Preliminary Drainage Report

Overlook at Homestead Subdivision El Paso County, Colorado

PCD Filing No.: **SP238**

Prepared: August 7, 2023

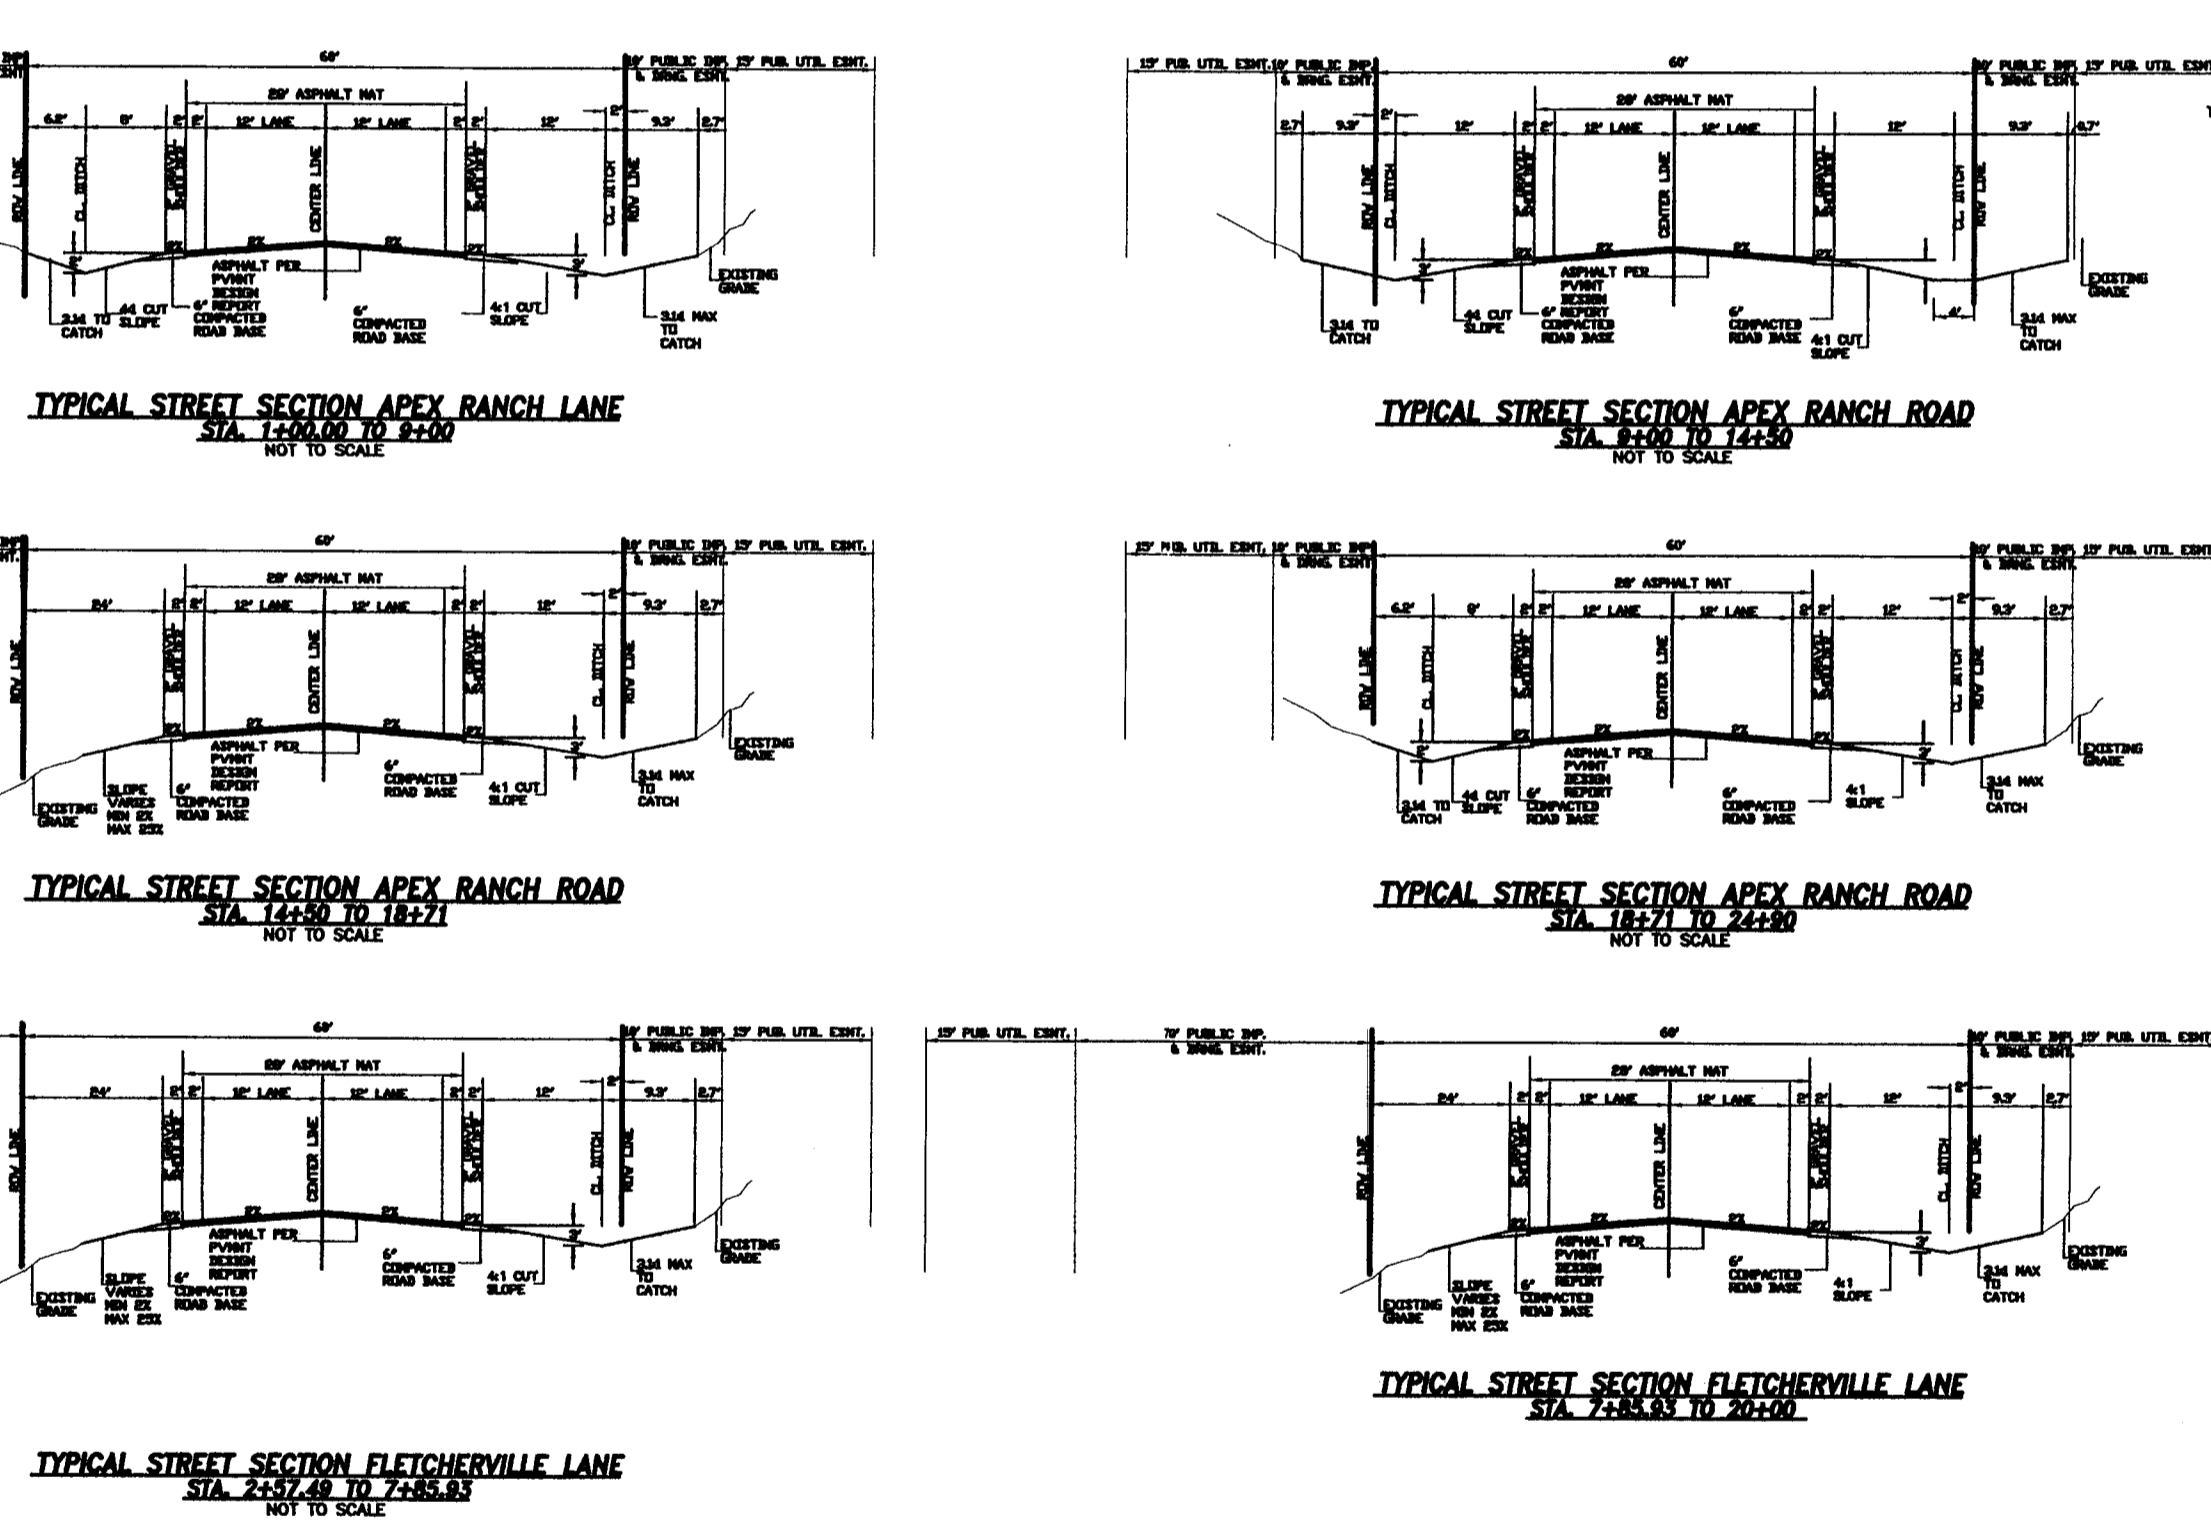
Provide excerpt of impervious values used for this basin

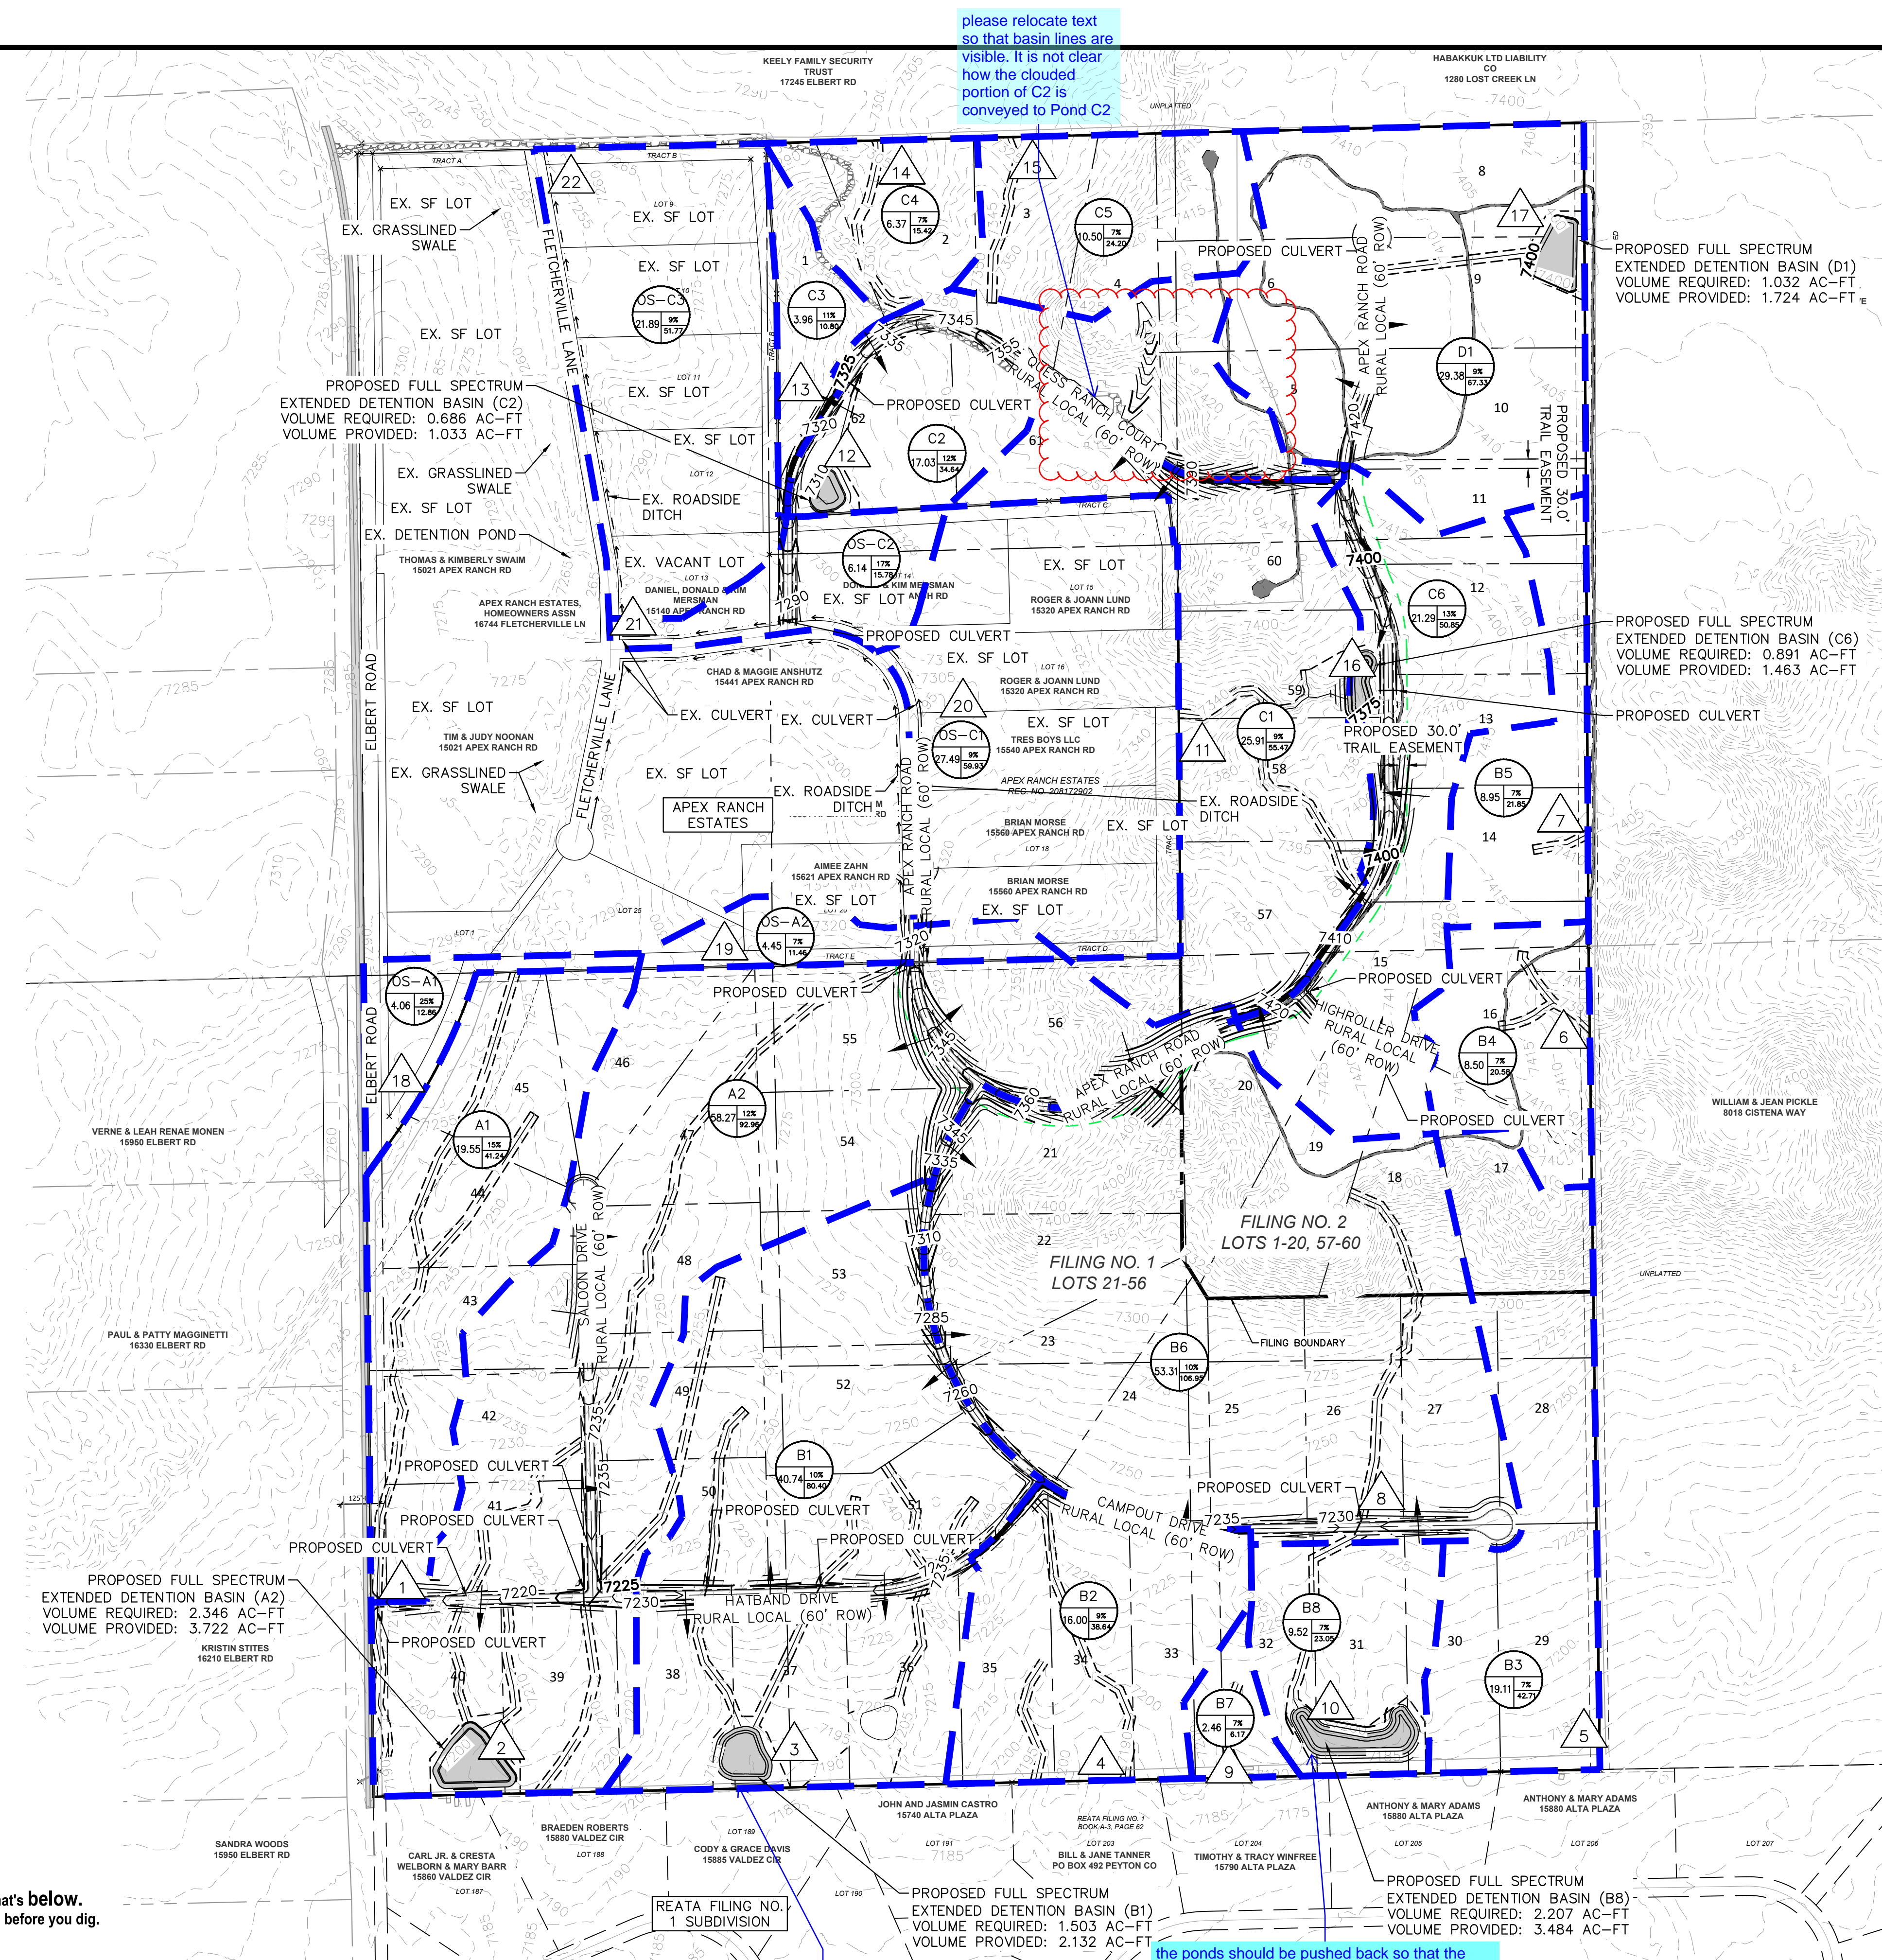
please relocate text so that basin lines are visible. It is not clear how the clouded portion of C2 is conveyed to Pond C2
